May 18, 2021

Re: McLean Zone 3 Overlay District
Application for Design and Site Plan Review

A2.01A

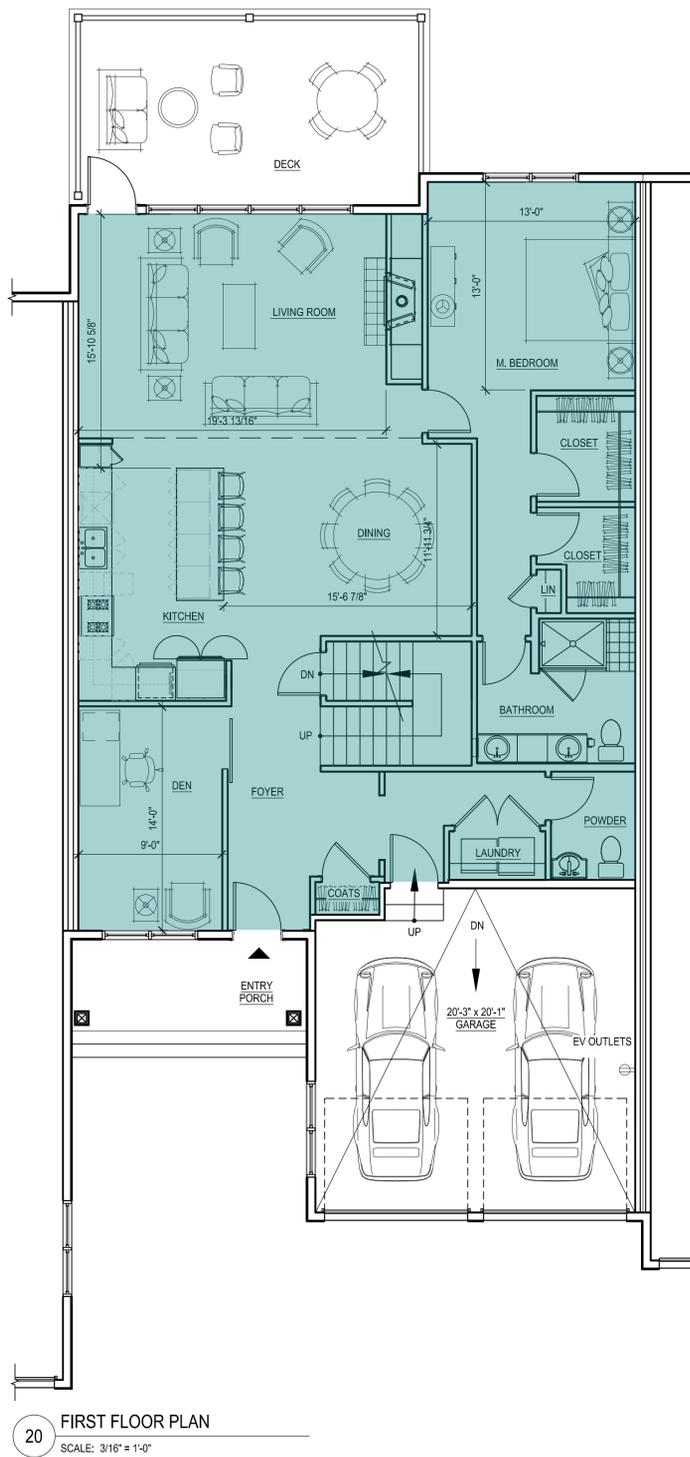
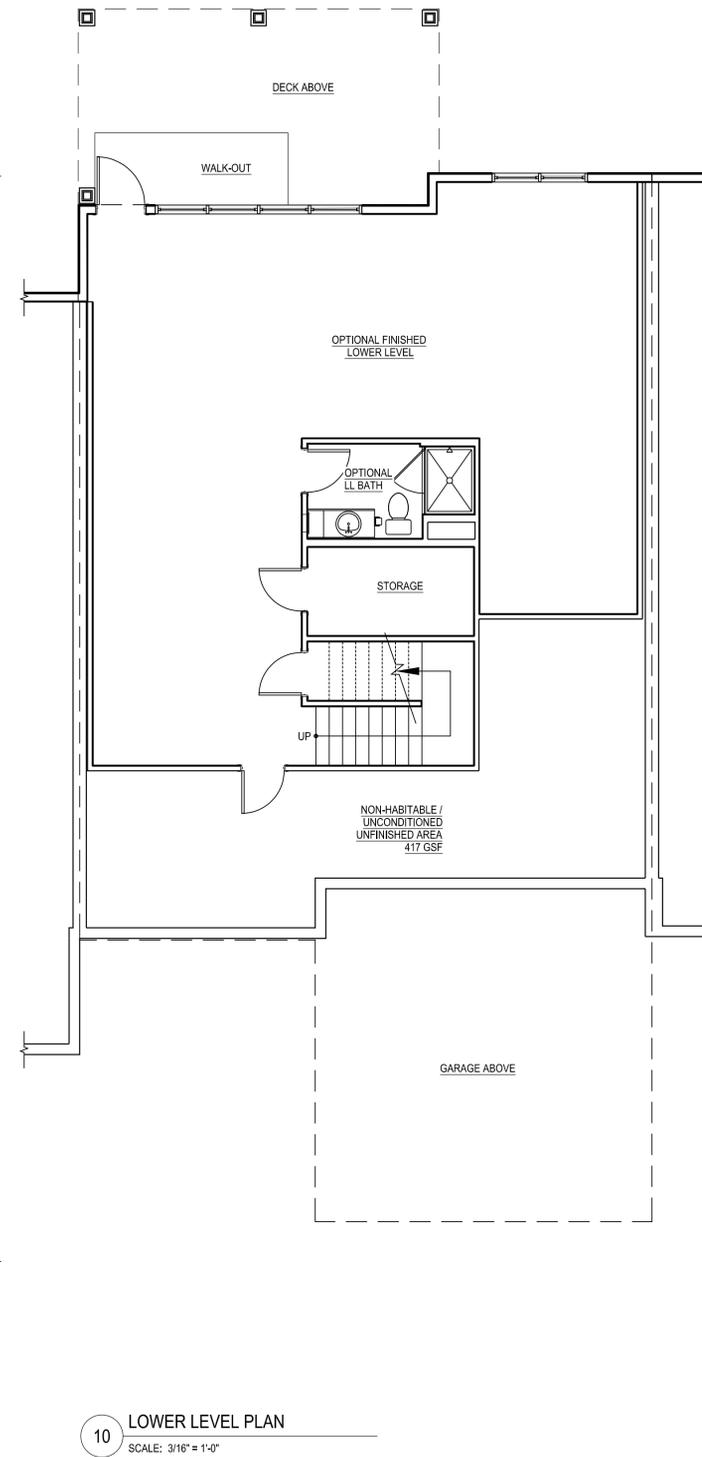
On Sheet A2.01A detail 10 of the lower level (and most of the subsequent sheets) the lower level is not dimensioned at all. Based on the By-Law's definition of Gross Area, this would be calculated from the dimensions of the outside face of the foundation wall. The necessary dimensions are not provided.

On Sheet A2.01A detail 20 of the first floor there are quite a few dimensions given, for the most part these dimensions are interior space dimensions, which if complete would allow for a calculation of the Living Area, however if you look at the provided dimensions it is actually impossible to pull accurate measurements and calculate the areas. On this and many of the subsequent floor plans the location of the kitchen island is dimensioned, I have no idea how this would figure into the calculations of Gross or Living Areas?

Figure 3

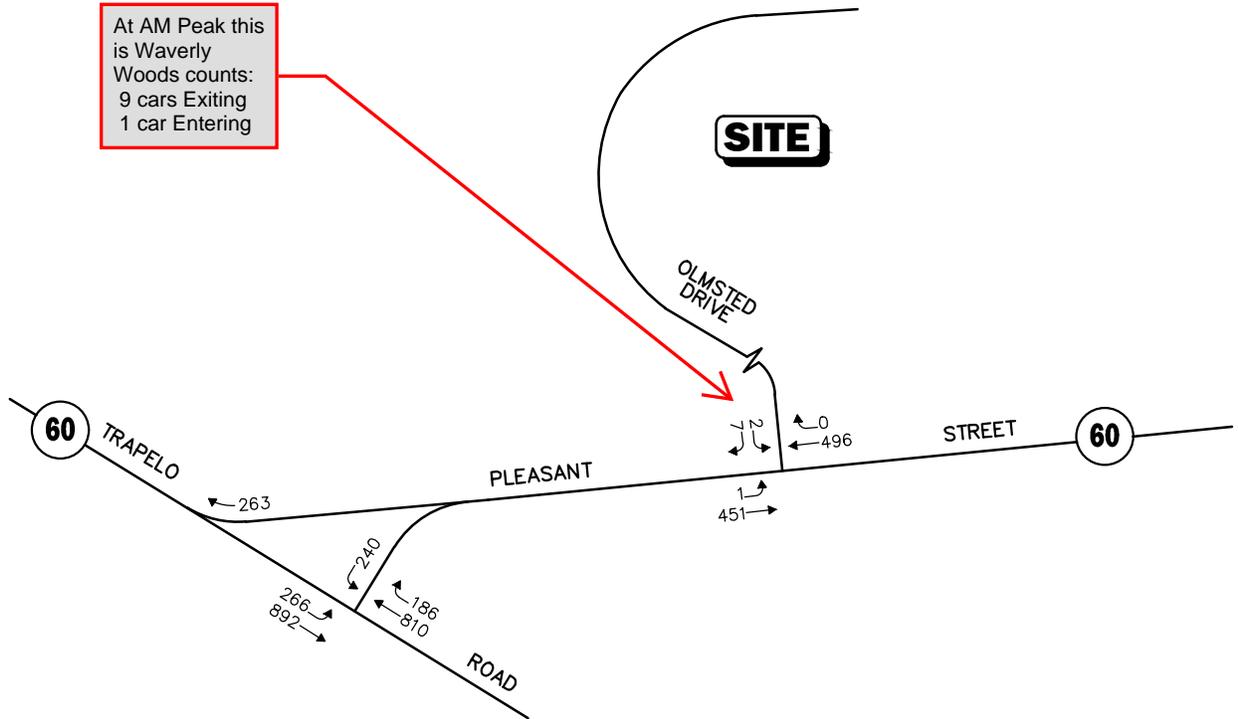
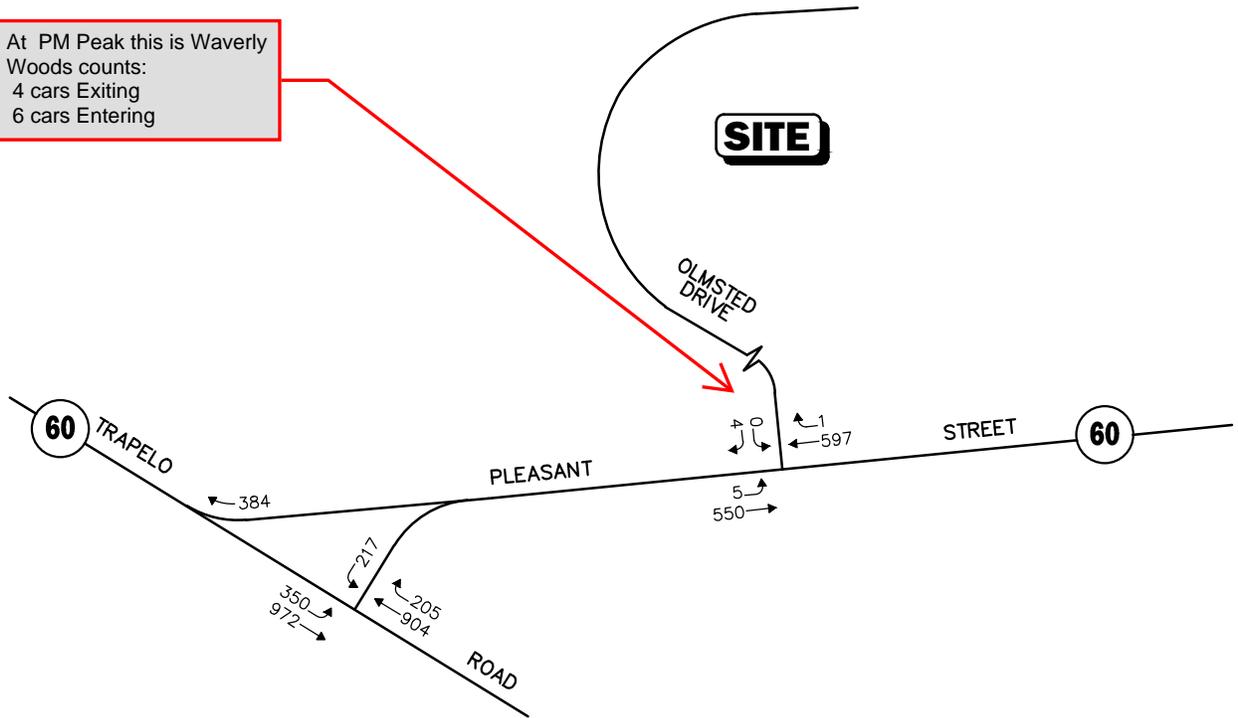
Where are the actual ATR Counts?

Evening Peak Hour??

At AM Peak this is Waverly Woods counts:
9 cars Exiting
1 car Entering

At PM Peak this is Waverly Woods counts:
4 cars Exiting
6 cars Entering

Figure 5

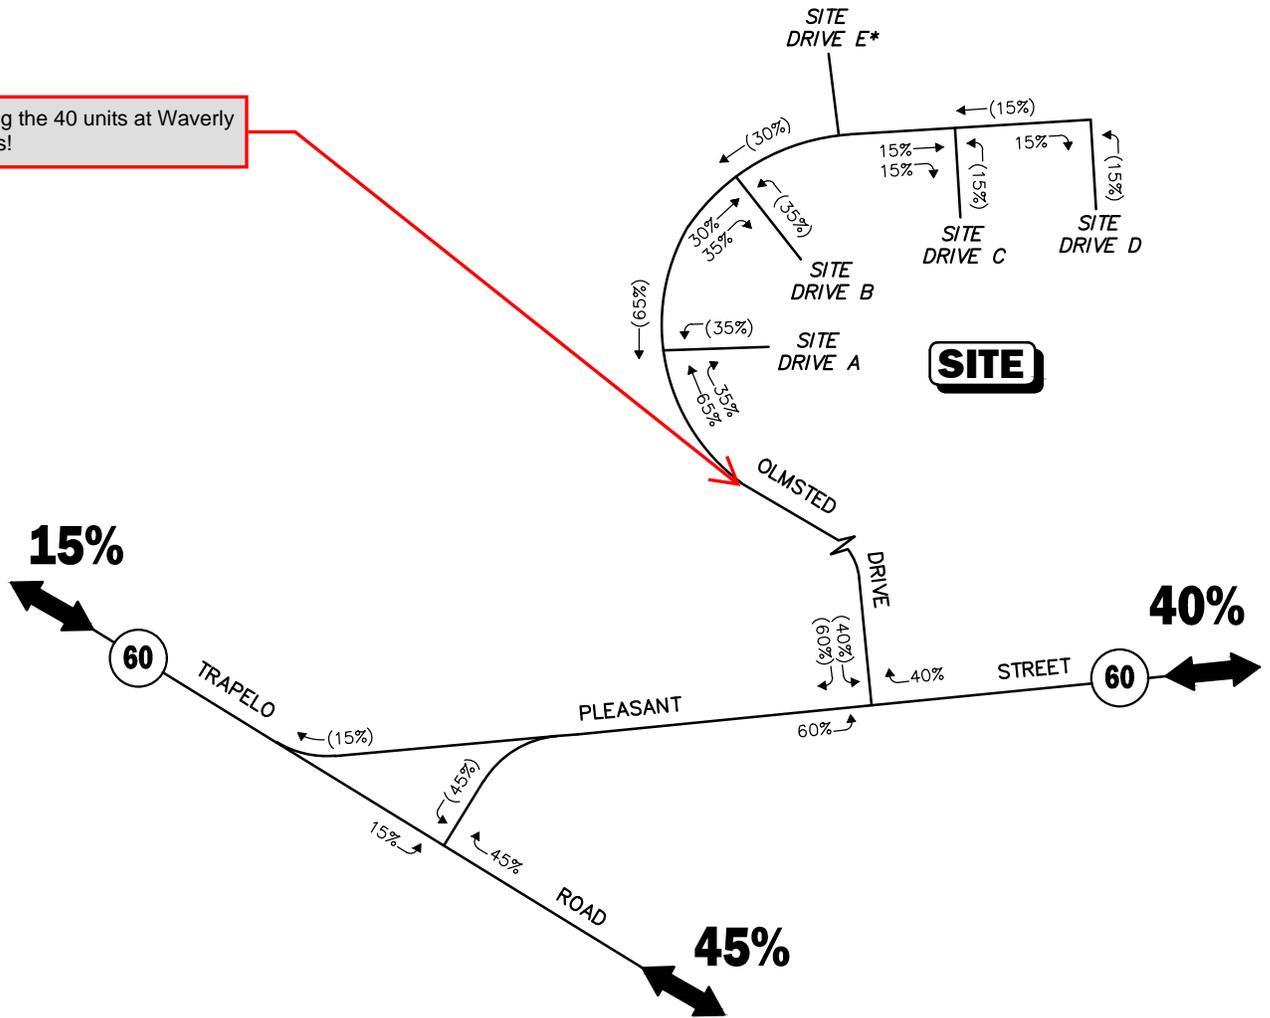
Missing the 40 units at Waverly Woods!

Figure 6

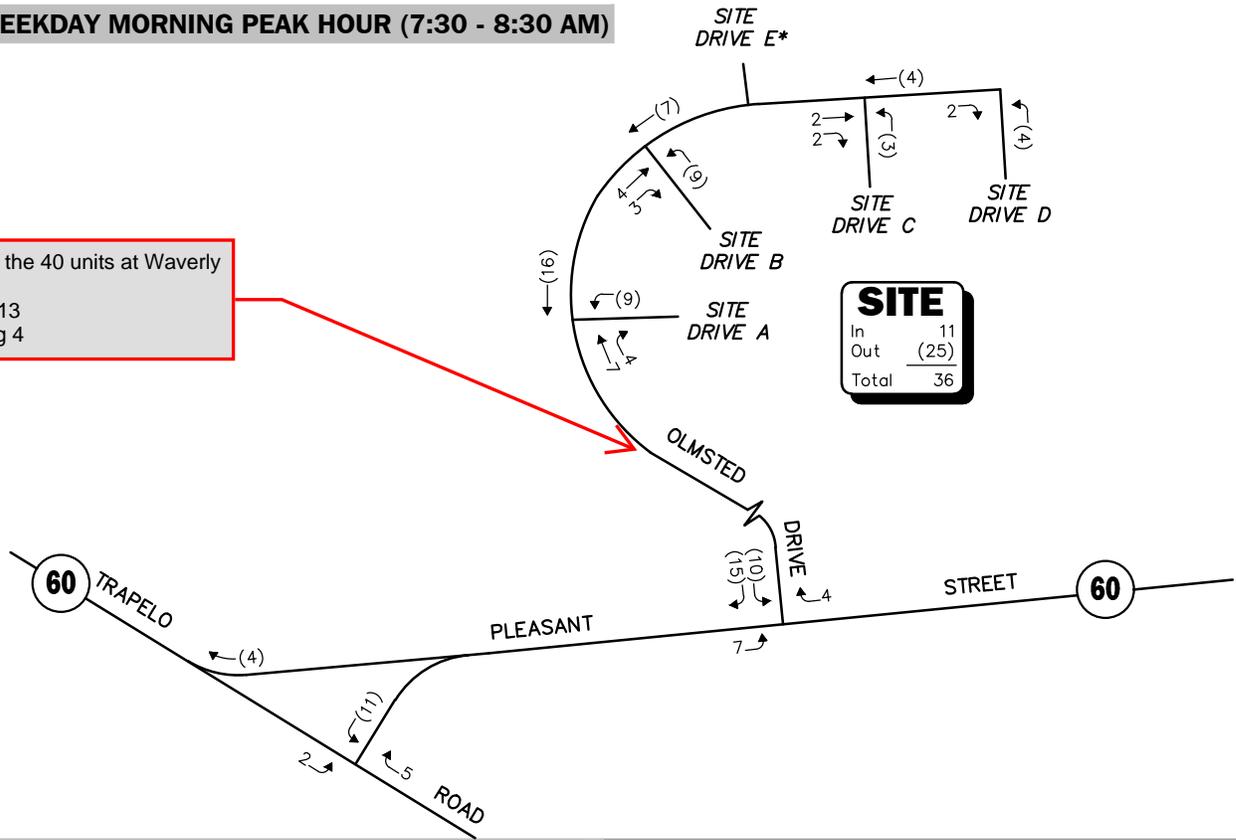
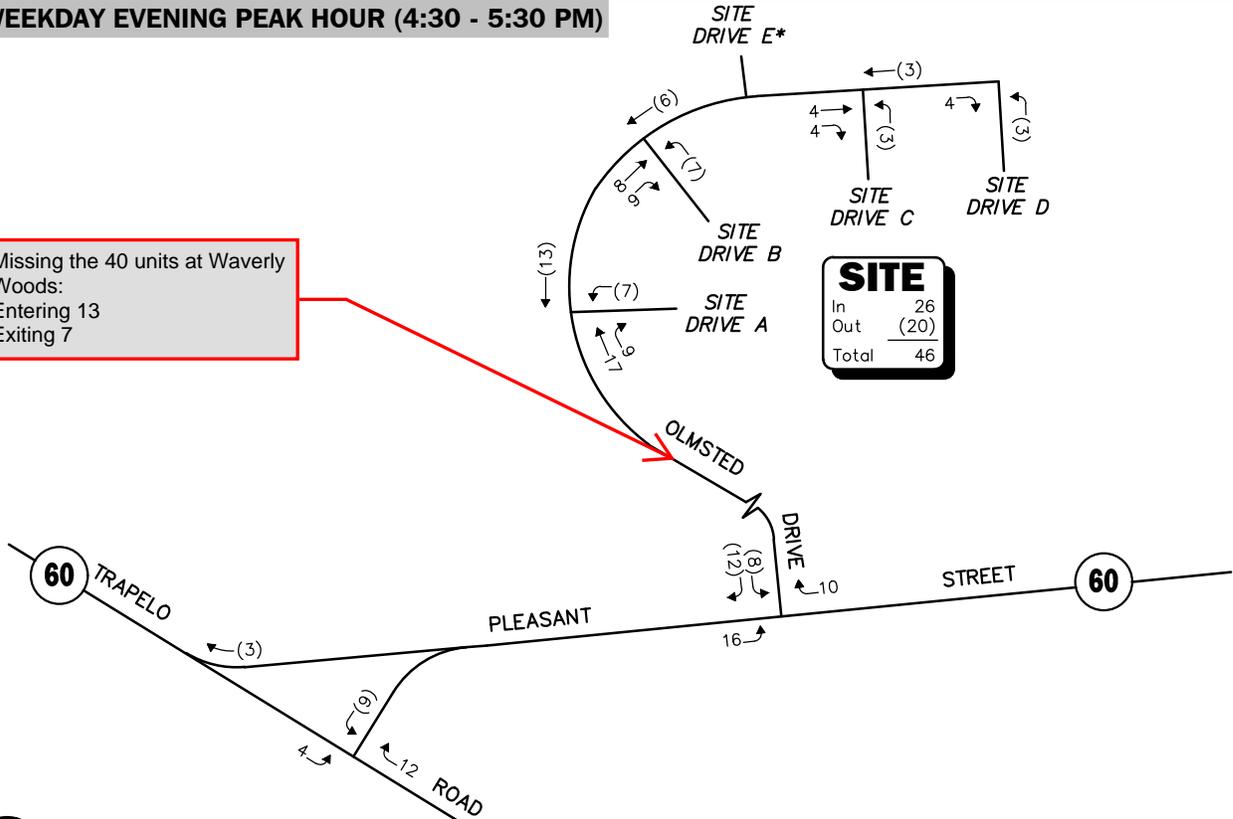
Missing the 40 units at Waverly Woods:
 Exiting 13
 Entering 4

Missing the 40 units at Waverly Woods:
 Entering 13
 Exiting 7

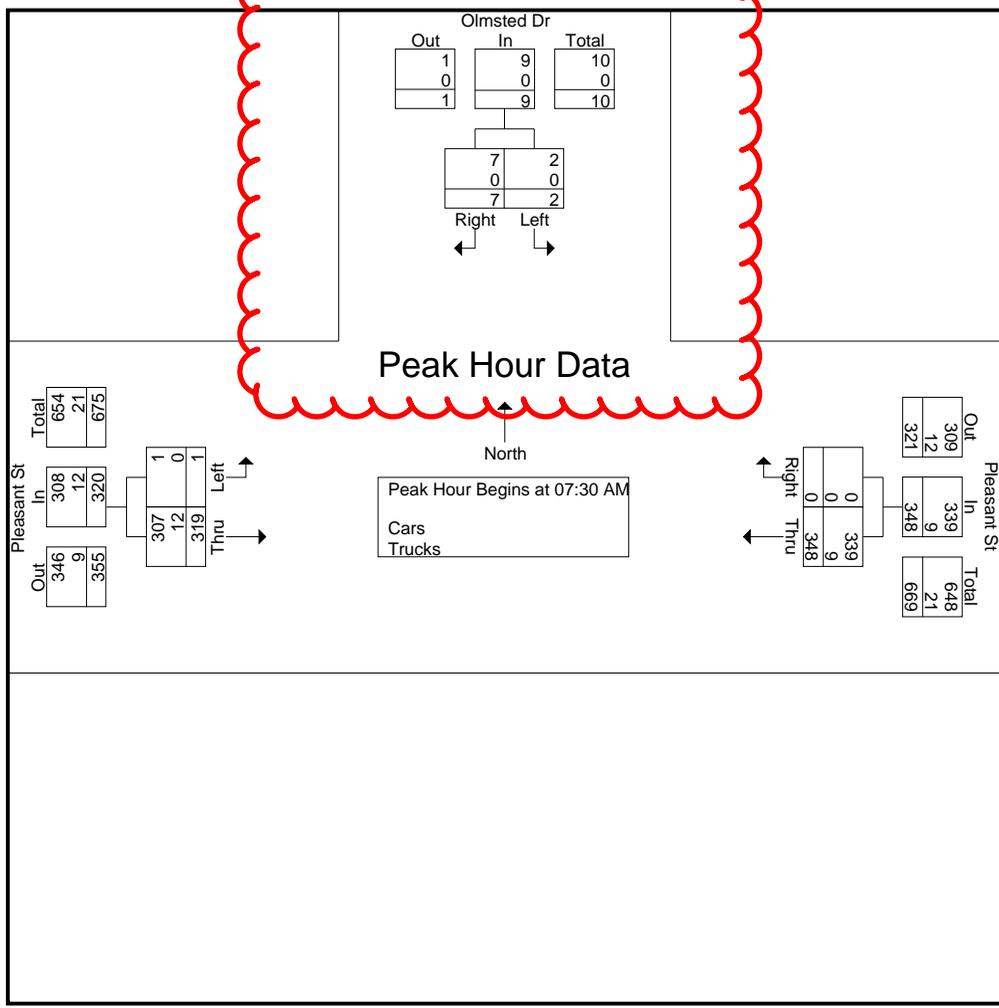
Waverly Woods,
should these be
grossed up 40%?

VAB C-4
INTERIM PLAN

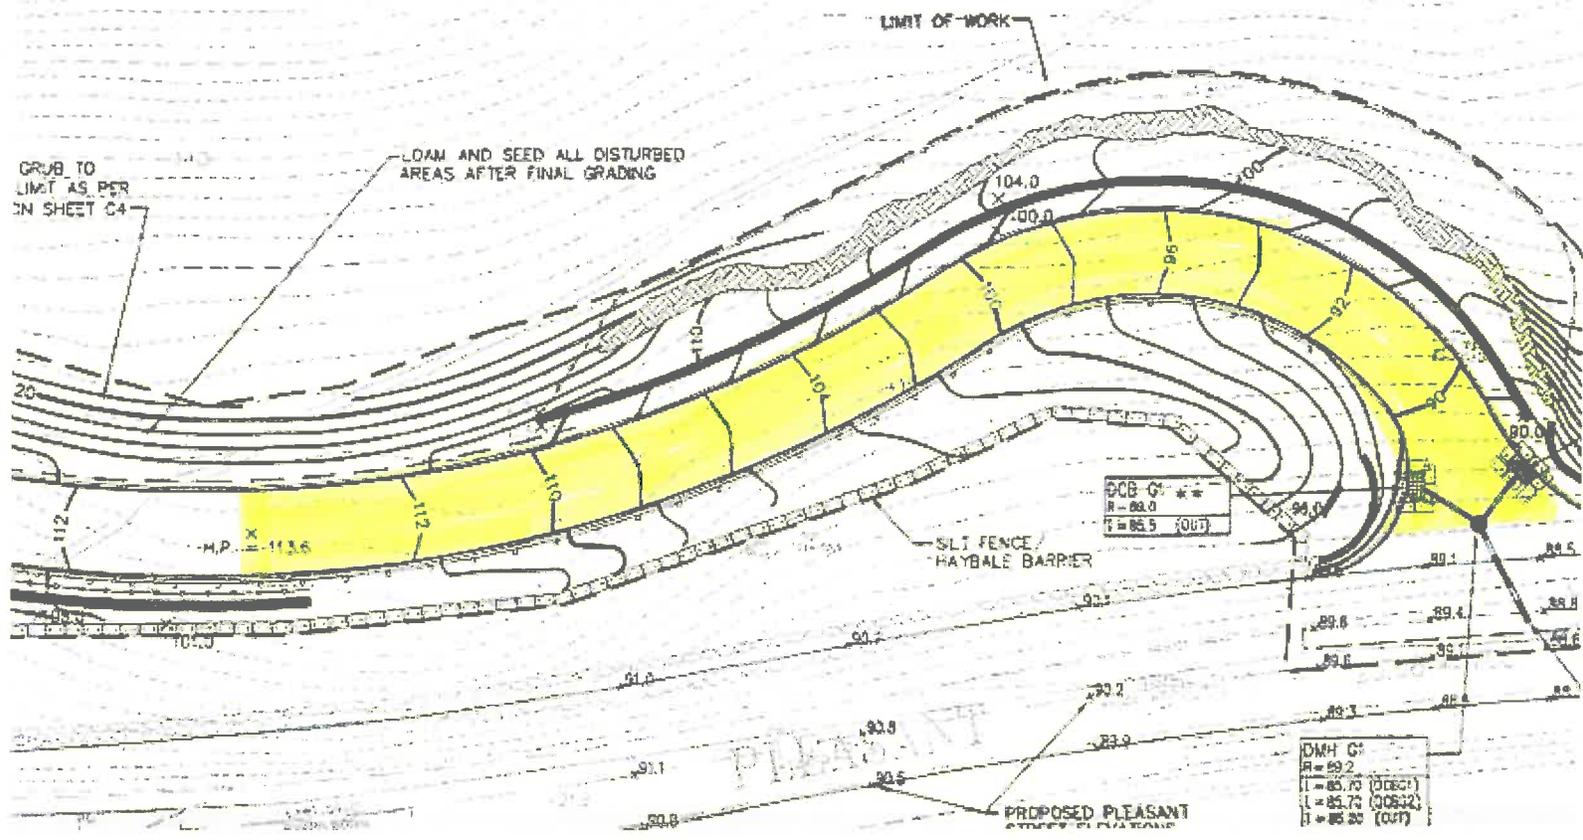
C. - ZONE 2 TIE-IN
NOT SHOWN

NO STORM-DETENTION
 NO INFILTRATION
 TSS THROUGH SUMPS ONLY

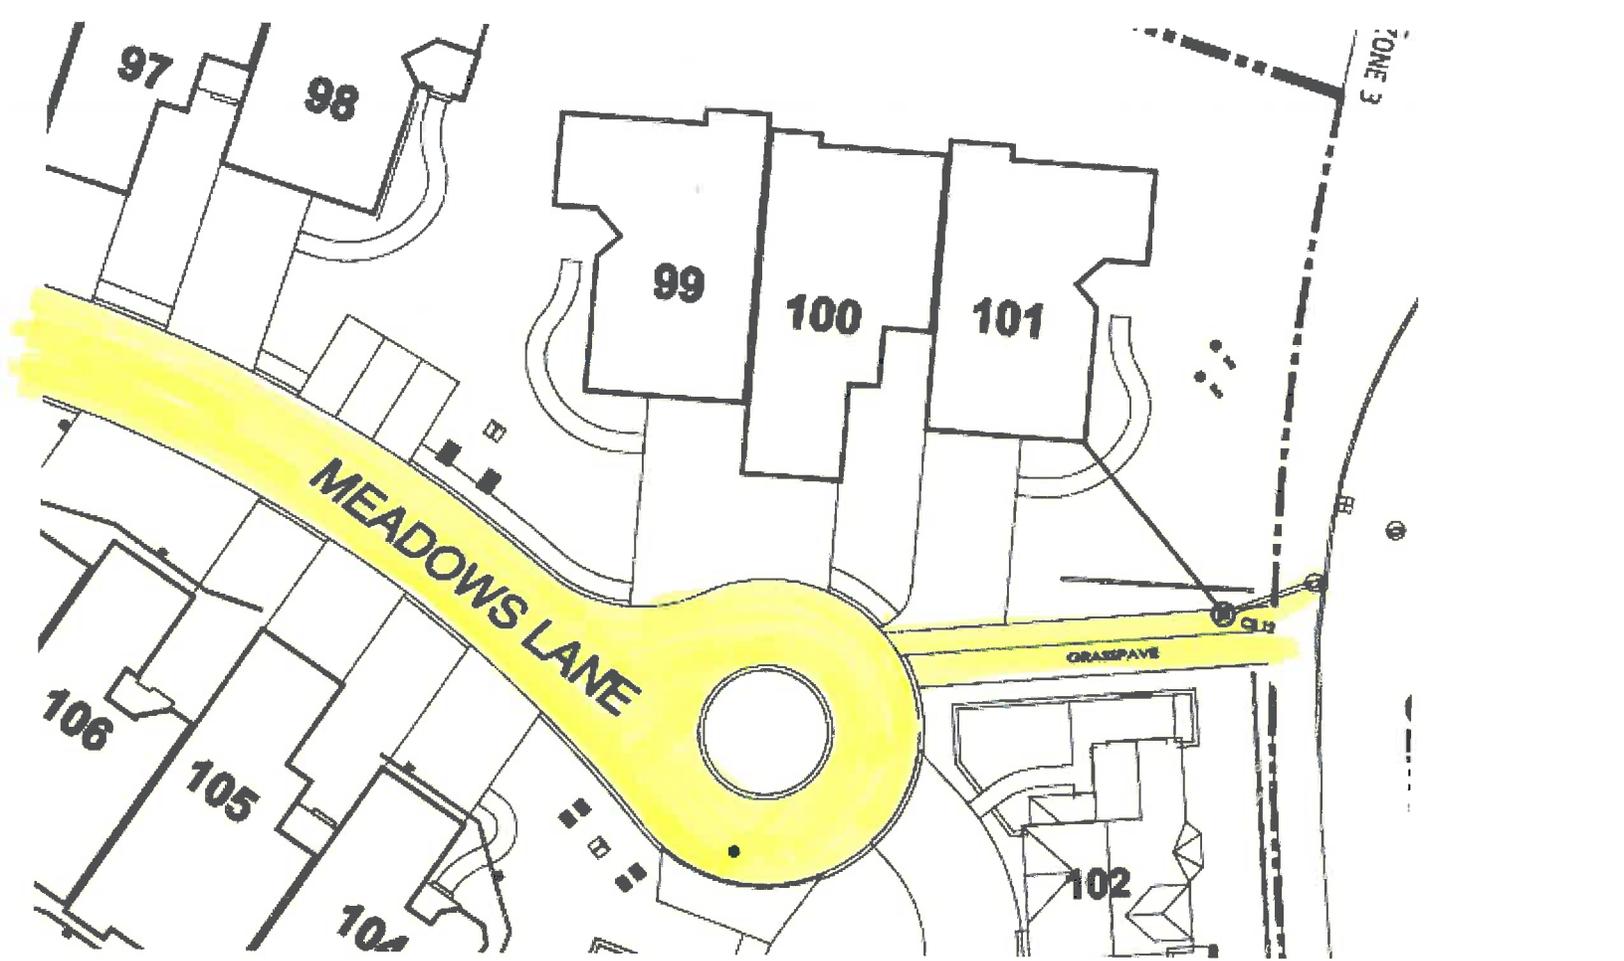
CAN'T VERIFY THESE

CAN'T FIND THIS STRUCTURE (IS IT IN ROADWAY?)

WAVELY WOODS MISSING

MEADOWS LANE MISSING
